Rep No.TR24-019 2024年5月27日 富士電機テクニカ株式会社

エアフィルタ(VFYシリーズ)一部形式仕様変更のお知らせ

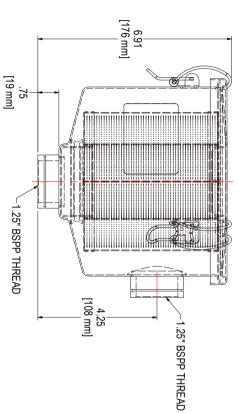
製品名 エアフィルタ シリーズ、名称 VFYシリーズ VFY032A 形式 VFY034A インレットの位置が変更になります。(右図のA部) 形式 新寸法(mm) 旧寸法(mm) 変更内容 VFY032A 108 116 VFY034A 109 116 2024年9月出荷分からを予定しています。 変更時期 (物量の推移によって前後することがあります) 変更理由 製造過程合理化による、機材変更の為 ・外形寸法図_VFY032A(変更後の図面) ・外形寸法図_VFY034A(変更後の図面) 添付資料 ・旧_外形寸法図_VFY032A(変更前の図面) ・旧_外形寸法図_VFY034A(変更前の図面)
